Christina Crespi Executive Director August 19, 2020

U.S. Army Corps of Engineers 803 Front Street Norfolk, VA 23510-1096

On behalf of the Board of the Miami Downtown DDA, we submit the following comments regarding the US Army Corps of Engineers' Miami-Dade Back Bay Coastal Storm Risk Management Feasibility Study, or "Back Bay" Study, and its most recent recommendations (June 5, 2020) to address storm surge in Greater Downtown. We believe these comments should be addressed in order to ensure strong and unconditional support from downtown stakeholders for the Feasibility Study, the Chief Engineer's Report, and the subsequent authorization and appropriation process with Congress.

# USACE BACKBAY TSP PROPOSED at Brickell Bay Drive

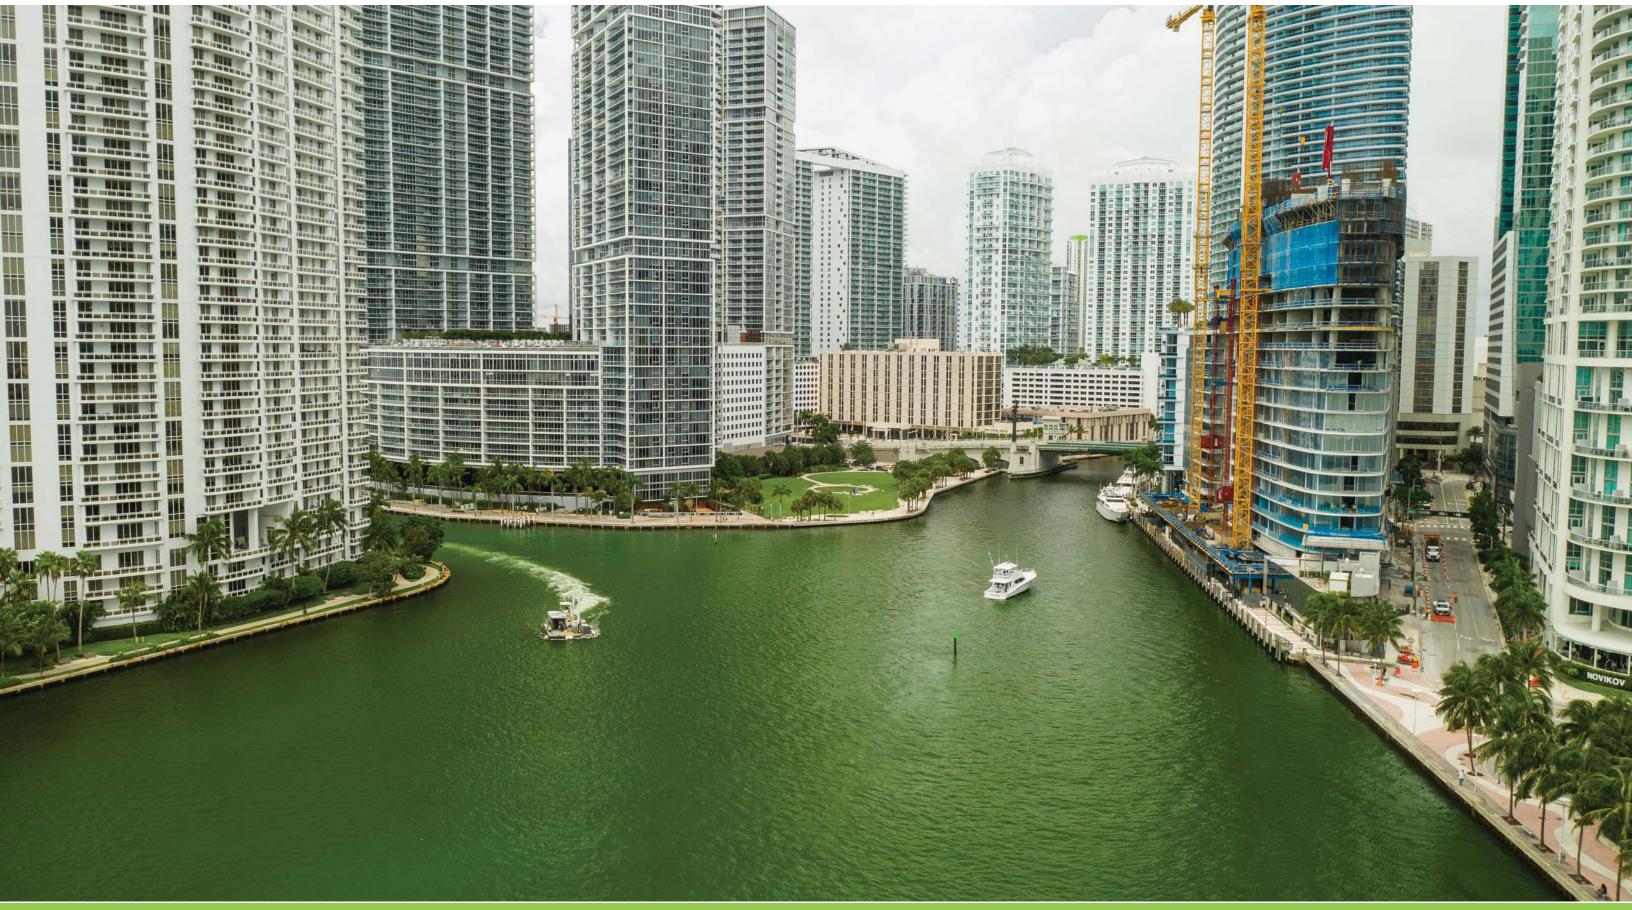
- The TSP's implementation of floodwalls south of the river would effectively end the Brickell Baywalk and render existing marinas obsolete.
  - The Brickell floodwall does not protect Brickell Key, which houses more than 5,000 people. Nor does it take into account the Brickell Key Bridge, which is the only ingress and egress for those residents, especially as an evacuation route during large storms.

- The floodwall planned for Brickell directly conflicts with the goals of that plan, and public access points for kayak and paddleboard launches will not be possible nor permitted.

Therefore, in lieu of a floodwall running parallel to Biscayne Blvd in the CBD and another floodwall in Biscayne Bay running parallel to the Baywalk in Brickell (and cutting off Brickell Key), we respectfully request that you instead design, engineer and implement a hybrid solution that includes nature-based features, such as breakwaters, living shorelines, nearshore artificial reefs and mangrove fringes in coastal areas, and elevated berms and bioswales in upland areas, with some smaller floodwalls as a layered and tiered defense. This alternative would also be flexible to future adaptations.
